Operational Surface Water Management Plan

Lidsdale Ash Repository 2026

Title	Operational Surface Water Management Plan - Lidsdale Ash Repository 2025
Approved by GPM Environment Manager	John Pola
Signed	
Dated	31st March 2026

Figure 4.1 New LDP3 Treatment System

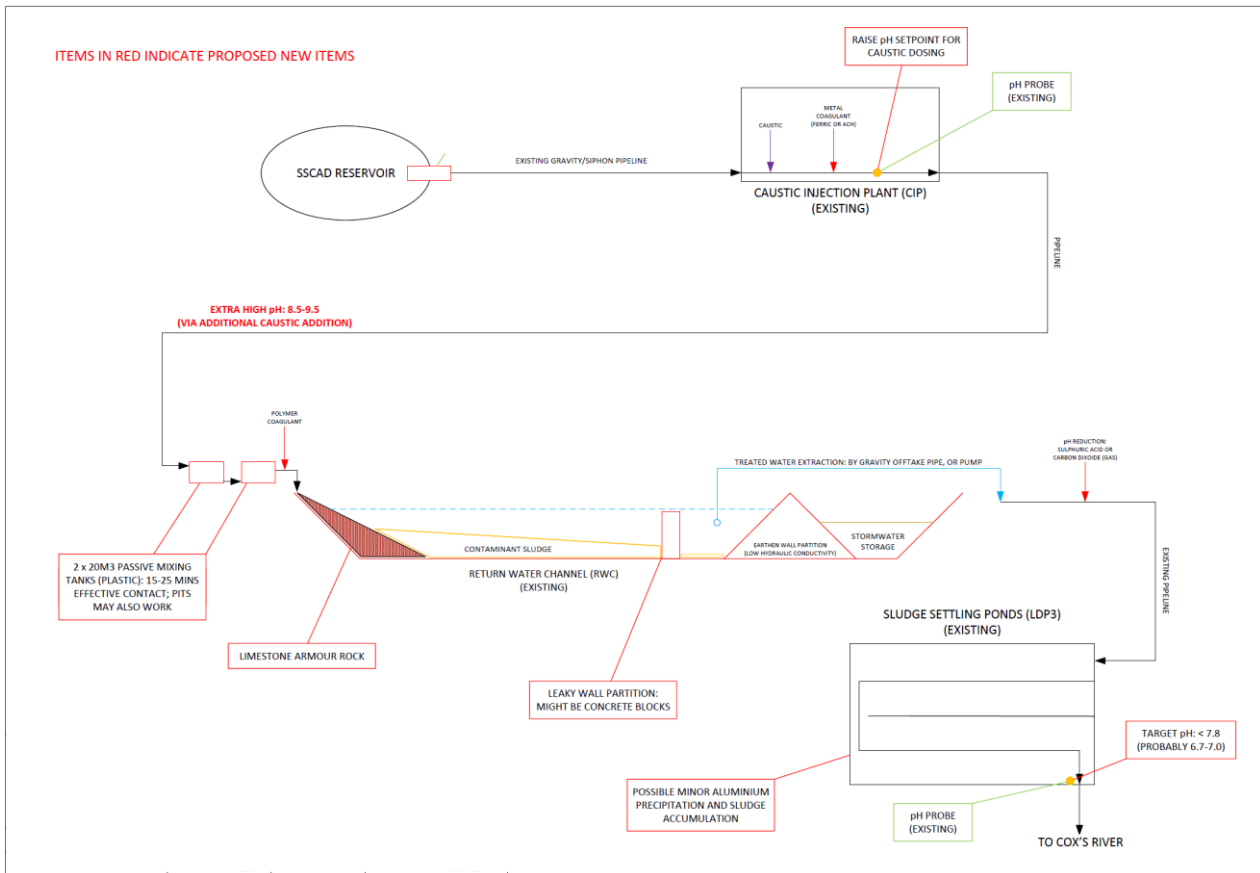
- Little information is provided in the OSWMP regarding the Caustic Injection Plant (CIP). WaterNSW considers the potential impacts of this activity are relevant and should also be included in the OSWMP including specific details of the current water quality within the SSCAD (including heavy metals and metalloids) and details of the treatment process and the expected quality of treated water discharges for all parameters. The OSWMP should also include when use of the CIP is triggered (i.e., anticipated rainfall thresholds, water quality exceedances), and monitoring is required prior to treatment, and prior to discharge to ensure compliance with the EPL

Agency	Date provided	Comments	Where addressed
WaterNSW	4 th February 2025	The OSWMP should include a detailed water balance for the site to demonstrate that storage volumes can effectively manage contaminated water on site	Added as Appendix D
		Little information is provided in the OSWMP regarding the Caustic Injection Plant (CIP). WaterNSW considers the potential impacts of this activity are relevant and should also be included in the OSWMP including specific details of the current water quality within the SSCAD (including heavy metals and metalloids) and details of the treatment process and the expected quality of treated water discharges for all parameters. The OSWMP should also include when use of the CIP is triggered (i.e., anticipated rainfall thresholds, water quality exceedances), and monitoring is required prior to treatment, and prior to discharge to ensure compliance with the EPL	Section 4.2 added to provide more detail about the water treatment system.

Figure B.1 Surface water monitoring locations

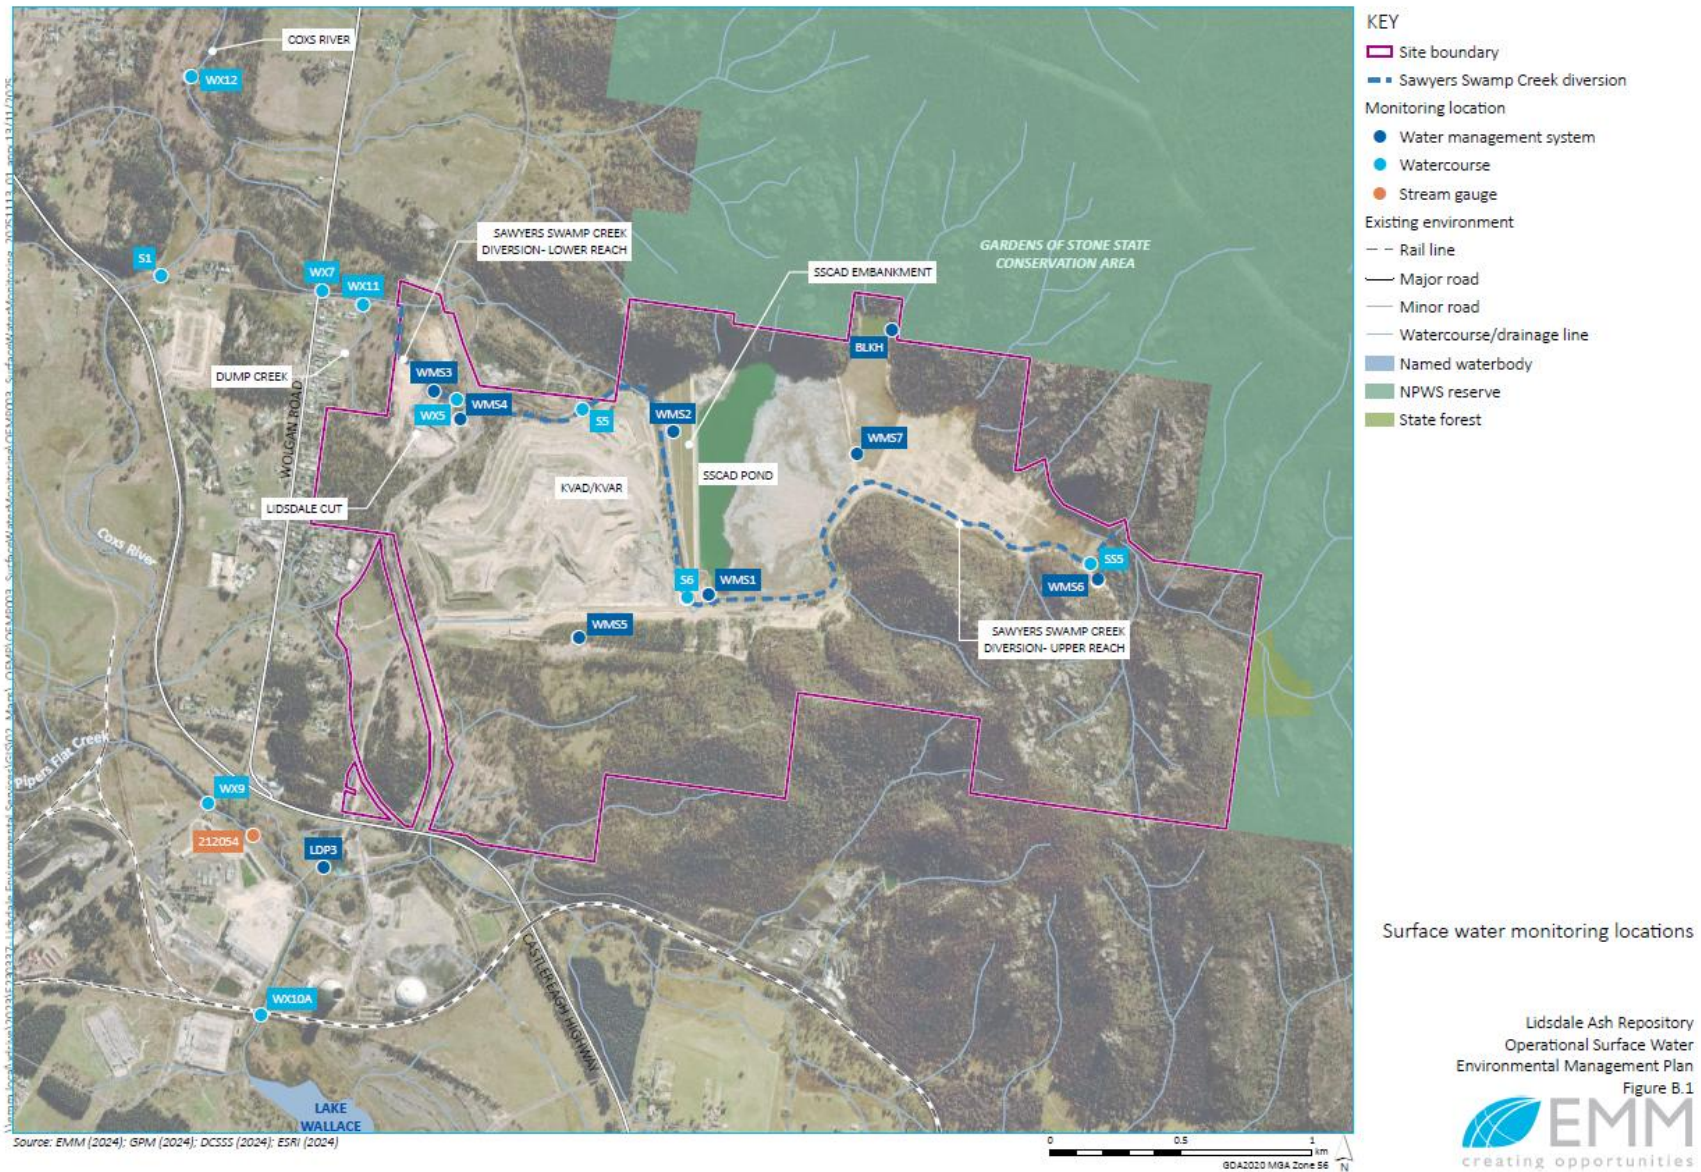
- There is no discussion as to what the 4 groundwater monitoring sites (A9, A17, GW10 & GW11) identified in Figure B1 as “extra water quality and water level sites – not part of OEMP” are for, and why they aren’t included in the OEMP. WaterNSW considers that more detail regarding these monitoring sites should be included as part of the sites OGWMP, even if non-routine sites

Revision 3 of this plan was provided to WaterNSW and Fisheries NSW on the 21 st of July 2025 for comment close-out.			
WaterNSW	7 th August 2025	Thank you very much for sending through the updated plans. Water NSW has now reviewed the and have no further comments.	N/A
Fisheries NSW	1 st September 2025	<p>Thank you for your correspondence.</p> <p>I have reviewed the updated OSWMP and am satisfied that my previous comments have been addressed and endorse the revised plan.</p>	N/A
Revision 4 of this plan was provided to WaterNSW and Fisheries NSW on the 8 th of September 2025 for comment close-out			
NSW EPA	22 nd October 2025	<p>Relocation of surface water monitoring location</p> <p>The EPA supports the request to relocate LDP 20 [read:EPL20] (S5) surface water sampling point approximately 200 m downstream due to increasing inaccessibility and workplace safety matters.</p>	<p>Figure 5.3 in the OEMP and Figure B.1 of this document have been updated to present the updated monitoring location for S5 (EPL20).</p>
